Addendum to Final Report  
for  
**UNITED STATES DEPARTMENT  
OF THE INTERIOR**  
BUREAU OF OCEAN ENERGY MANAGEMENT,  
REGULATION, AND ENFORCEMENT  
WASHINGTON, DC 20240  
**FORENSIC EXAMINATION OF DEEPWATER  
HORIZON BLOWOUT PREVENTER**  
CONTRACT AWARD No. M10PX00335

Report No. EP030842  
30 April 2011

United States Department of the Interior, Bureau of Ocean Energy  
Management, Regulation, and Enforcement  
Forensic Examination of Deepwater Horizon Blowout Preventer  
Addendum to Final Report

**Figure B Comparison of the original CAD file compared to the updated CAD file for the Lower BSR block (red) provided on March 31, 2011**

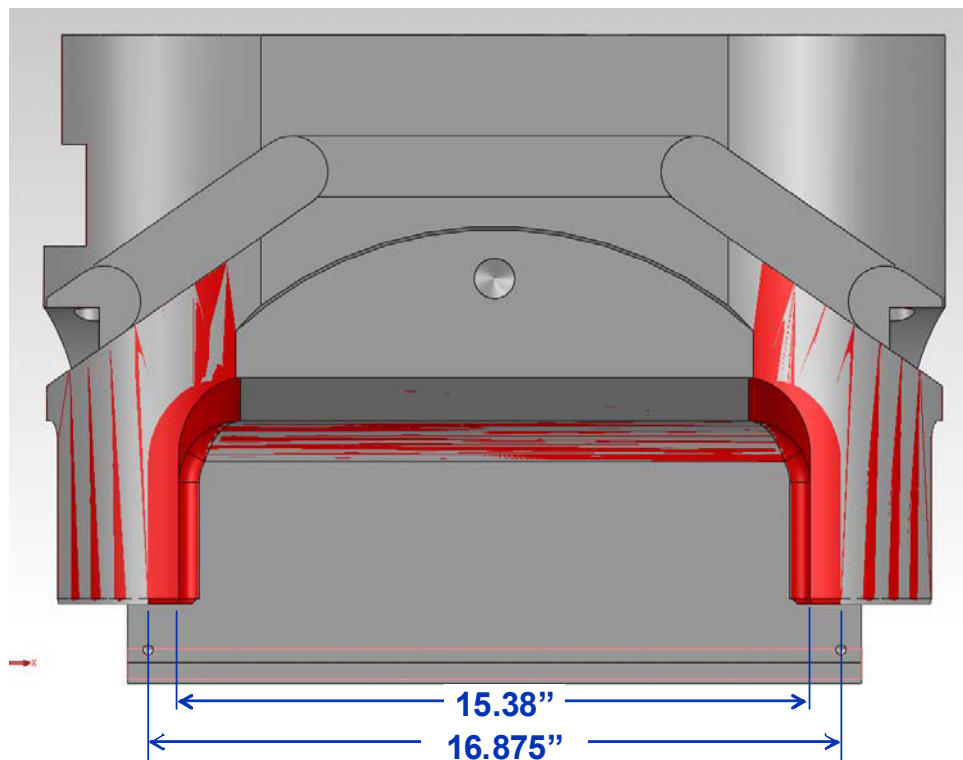
1. Included latest Cameron CAD geometry for the lower BSR block, which was provided to DNV by Cameron on March 31, 2011, after DNV had issued the Final Report on March 20, 2011.
2. Included the constraints of the wellbore in the FEA model.
3. Provided allowance for the compressibility of the side packers in the Ram geometry.
4. Positioned the pipe initially with an offset of 0.5 inch from the side of the wellbore.

Ad 1: The CAD files originally provided by Cameron for the lower BSR block reflected geometry different from the lower BSR block recovered from the Deepwater Horizon BOP. Cameron discovered this and provided the updated CAD file for the Lower BSR block on March 31, 2011. The primary difference noted between the CAD files for the two BSR blocks was the size of the opening of the relief cavity on the top side of the lower BSR block. A comparison between the original and revised versions is given in the Figure B, with the updated lower BSR block geometry shown in red. The cavity opening was measured as 15.38 inches in the updated lower BSR block, compared to 16.875 inches for the originally provided lower BSR block CAD geometry. The revised FEA model used the updated lower BSR block geometry.

**Revised Figure 134 FEA Model of BSR Blade Surfaces and Off-Center Drill Pipe**

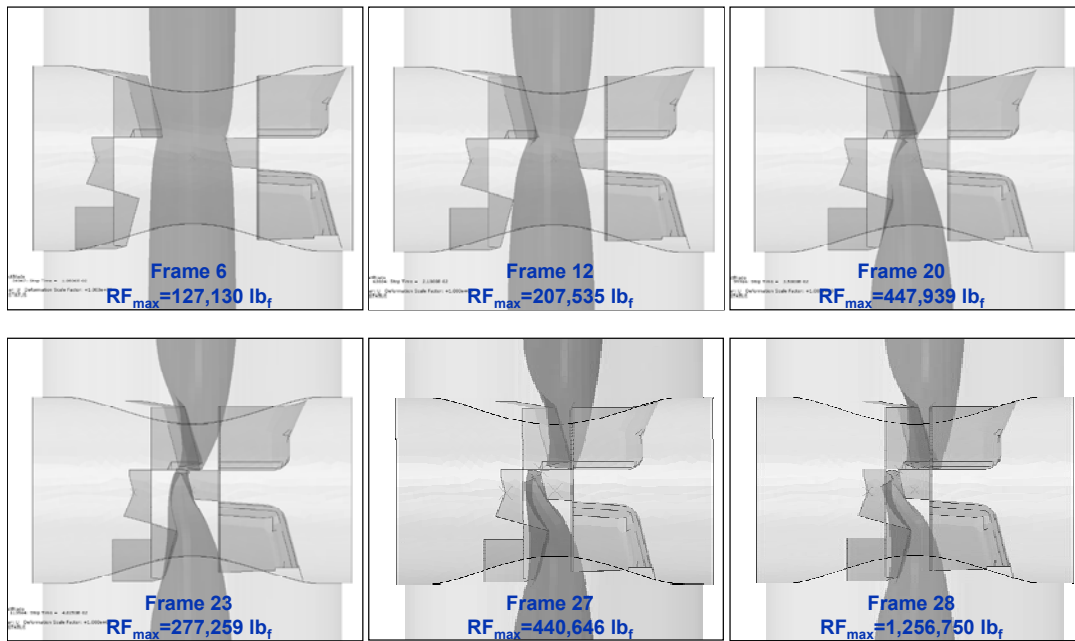
- Page 156 – Paragraph directly following Figure 133 – Line 2:
  - Substitute “(displaced 0.5 inches from the inside wall of the wellbore as illustrated in Figure 134).”
  - In place of “(displaced to the far side of the wellbore as illustrated in Figure 134).”
- Page 156:
  - Substitute Revised Figure 134
  - In place of Figure 134

**Revised Figure 139 Progression of Off-Center BSR Shear Model - Side View**

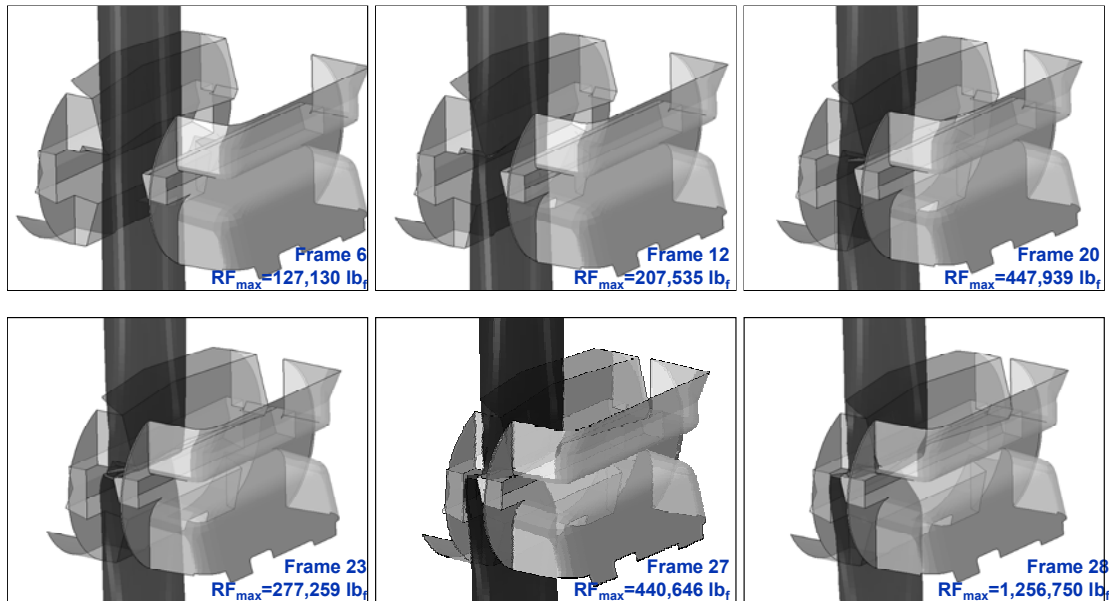
- Page 160 – Starting with paragraph directly below Figure 138 and continuing through Page 165 and stopping with the replacement of Figure 148:
  - Substitute all text and figures with the following:

The progression of the shear cut for the model with off-centered drill pipe is shown in Revised Figure 139 and Revised Figure 140. With the pipe off center in the wellbore (displaced 0.5 inches from the inside wall of the wellbore as illustrated in Figure 134), the corner of the upper blade made the initial contact with the drill pipe (Frame 6). In Frame 12, the corner of the upper BSR blade has pierced the drill pipe and shearing has initiated. Because part of the pipe is outside of the upper BSR blade surface, only approximately 75% of the pipe is actually being sheared between the upper BSR and lower BSR blade surfaces (Revised Figure 141, Frame 23). Due to the shear initiation at the Kill Side end point of the upper BSR blade and the fact that less of the pipe was sheared between the upper and lower BSR blade surfaces, the calculated maximum shearing force / equivalent operating ram pressure was less than that calculated for the centered pipe model (1,882 psi equivalent pressure for the off-center pipe versus 2,408 psi equivalent pressure for the centered pipe).

The remainder of the pipe was deformed and sheared/torn outside of the upper BSR blade surface (Revised Figure 139 and Revised Figure 140, Frames 23, 27, and 28). There is tight clearance between the top blade face of upper BSR block and the opposite relief cavity on the lower BSR block, which provides a high resistance to closing the BSR blocks. The FEA model predicts that the tight clearance of these vertical surfaces initiates shearing in a vertical direction causing the corner of the pipe to be torn away. This would explain the physical evidence shown in Figure 58a (left side of photograph). The FEA

**Revised Figure 141 Top View Showing Deformation of Drill Pipe Outside of Shearing Blade Surfaces**

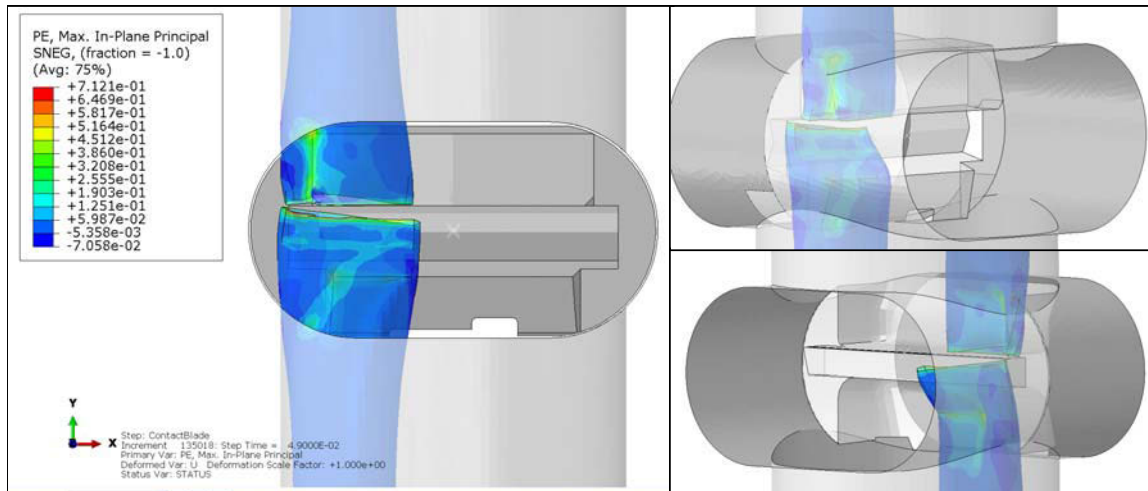
The configuration of the drill pipe for the condition shown in Frame 28 of Revised Figure 139 and Revised Figure 140 is referred to as the “final deformed” condition since it represents an operating ram pressure of 5,280 psi (greater than the available hydraulic pressure and thereby conservative for a maximum ram block displacement). Revised Figure 142 shows that, although the drill pipe was initially off-set 0.5 inch from the inside wall of the wellbore, the deformed pipe touches the wellbore surface both above and below the BSR cavity (Revised Figure 142). This is also the case for the lower operating ram pressures for Frames 23 and 27 (Revised Figure 139, Revised Figure 140,

**Revised Figure 143 Final Deformation of the Drill Pipe as Predicted by the Off-Centered Pipe Model; Upper BSR Block Shown on the Right**

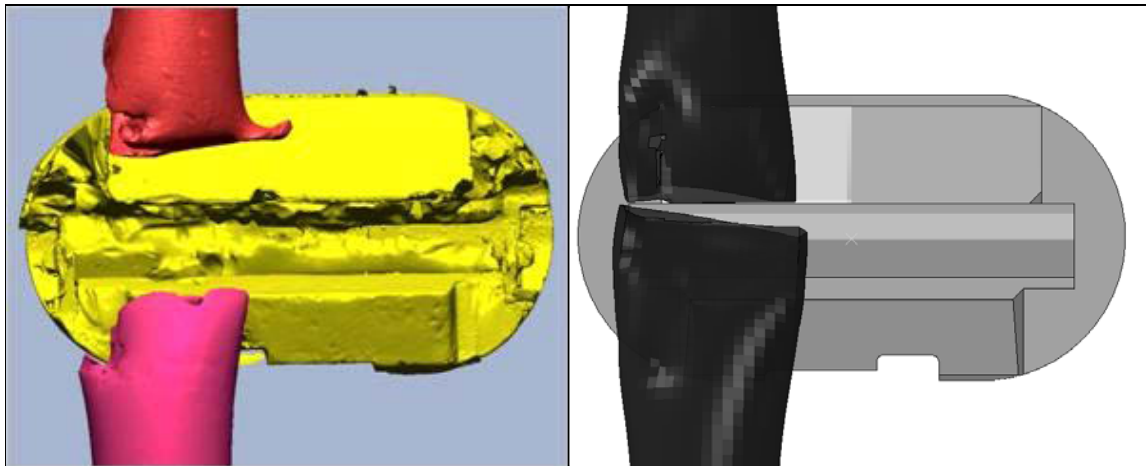
- For the FEA model, the ram block indentations on both the upper and lower segments of drill pipe were present and agreed with the recovered evidence (Revised Figure 143 and Revised Figure 145).

**Revised Figure 144 Comparison of Recovered Drill Pipe Segments and Final Model (Viewed facing the Upper BSR Block)**

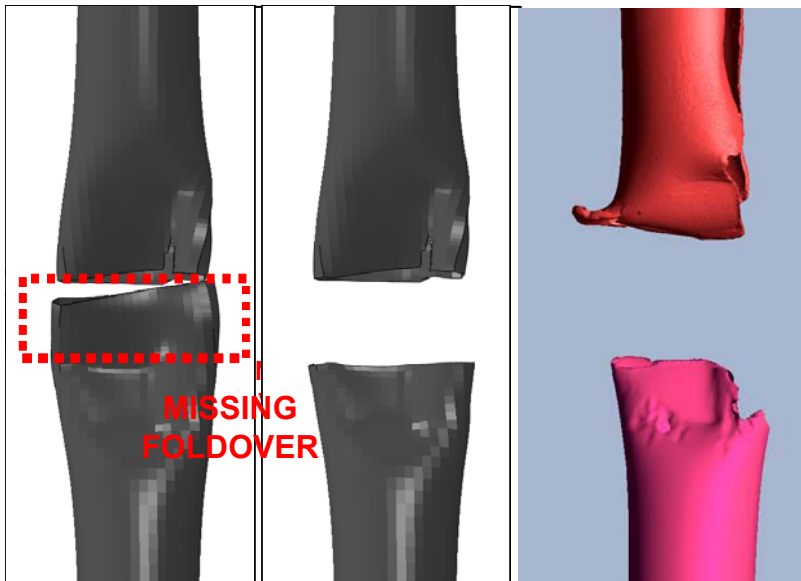
- If the “curled in” portion of upper segment of drill pipe was straightened, the recovered drill pipe would extend down to the cutting blade surface of the upper BSR block (Revised Figure 144).

- The notched (corners) missing on both the upper and lower segments of drill pipe correspond to the end of the top and bottom faces of the upper BSR block (Revised Figure 144).

**Revised Figure 145 Final Model Deformation Compared with Recovered Drill Pipe Laser Scans - 83-B and 94-B**

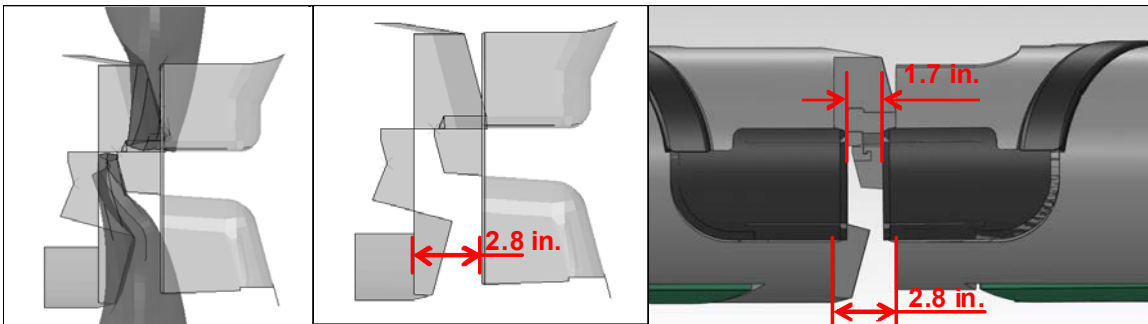
- The vertical “cuts” of the notches (Figure 61 and Revised Figure 145) of the top and bottom drill pipe sections correspond respectively to (1) the tight tolerance between the BSR upper ram block top face and the opposite relief cavity of the lower ram block (sharp vertical cut of the notch on the top drill pipe – 83-B) and (2) the larger gap between the BSR upper ram block bottom face and the opposite relief cavity of the lower ram block (more deformation and tearing of the vertical cut of the notch on the bottom drill pipe – 94-B).

- If the fold-over on the lower drill pipe segment was sheared (center image in Revised Figure 145), the FEA model matches the recovered lower drill pipe segment of the BSR cut.

**Revised Figure 146 Spacing of Upper and Lower BSR Blocks in Partially Closed Position**

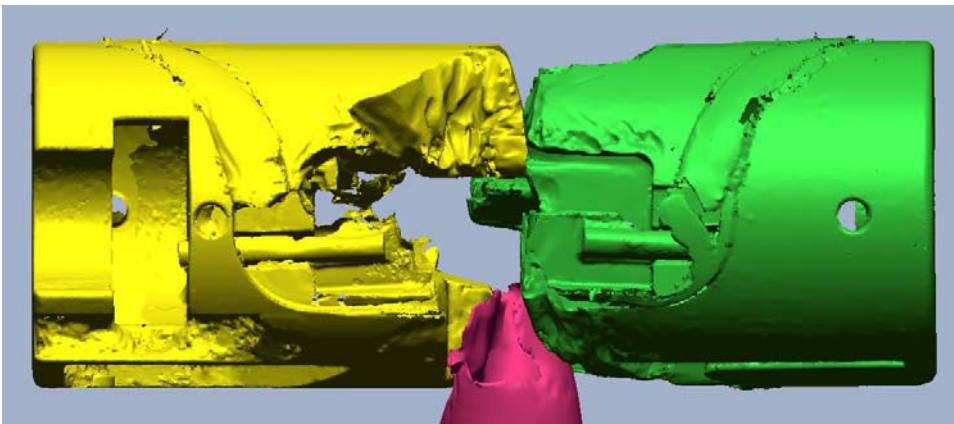
The FEA model predicted a 2.8-inch block displacement between the upper and lower BSR blocks for an applied force ( $RF_{MAX}$ ) of 1,256,750  $lb_f$  (equivalent to 5,280 psi). (See last frame in revised Figures 139 and 140.) The BSR would likely stall prior to the application of 5,280 psi, as the required pressure exceeds the available hydraulic system pressure (regulated to 4,000 psig), but the value of 5,280 psi was the model output closest to and not less than 4,000 psi. For comparison, the force in the prior frame is 440,646  $lb_f$  which is equivalent to 1,851 psi. At this point, the force is rapidly increasing with little

With an applied equivalent pressure of 5,280 psi (which is greater than the available hydraulic pressure), the upper and lower BSR blocks were 2.8 inches from being fully closed (Revised Figure 146 and Revised Figure 148). The side packers were 1.7 inches from making initial contact and sealing. The lower BSR blade was 2.2 inches from contacting the rear packers and sealing.

**Revised Figure 147 Alignment of Scan Models – 2.8 Inch Standoff between Blocks**

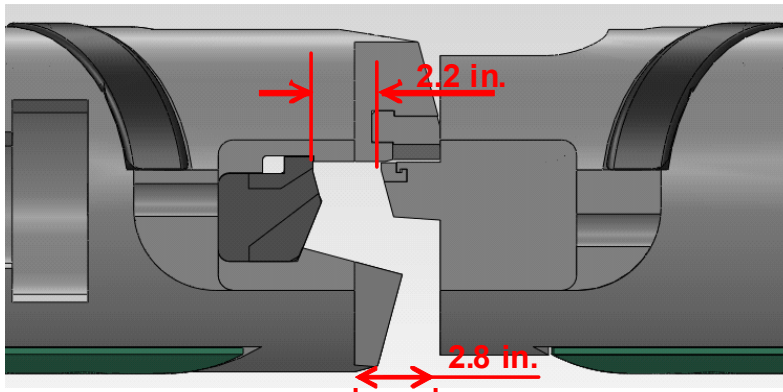
Further investigation was performed using the laser scanned models. The models of the upper and lower BSR blocks, and drill pipe segment 94 were assembled with segment 94 contacting the upper block (deformation features aligned – Revised Figure 147). With the blocks spaced 2.8 inches from fully closed and the lower block fit against segment 94 a large gap exists partly created by the BSR blocks not fully closing and partly due to erosion of the side packers, rear blade seal packers, and the ram blocks (especially on the Kill Side of the blocks).

**Revised Figure 149 Erosion Damage - BSR Blocks and Wellbore**

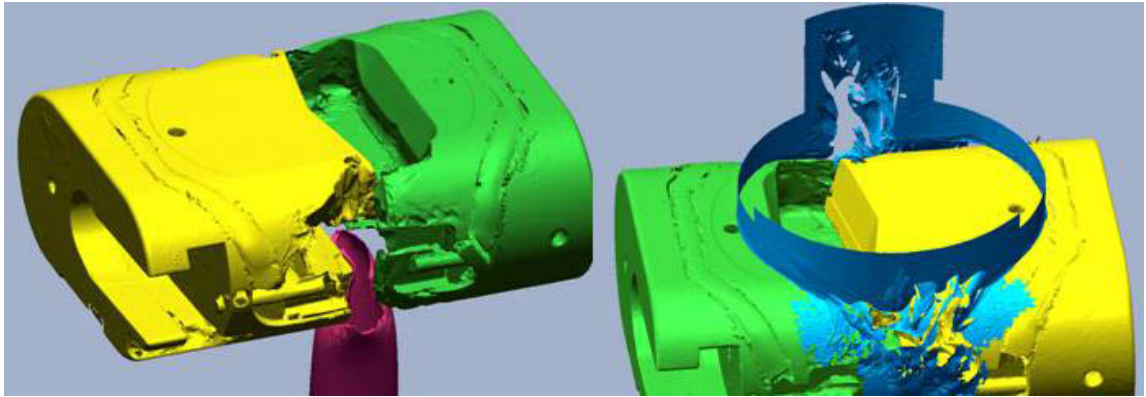
Revised Figure 149 shows the open cavity through the upper BSR block above the cut lower drill pipe segment. The image on the right shows the scan of the erosion in the wellbore along the kill side of the BSRs.
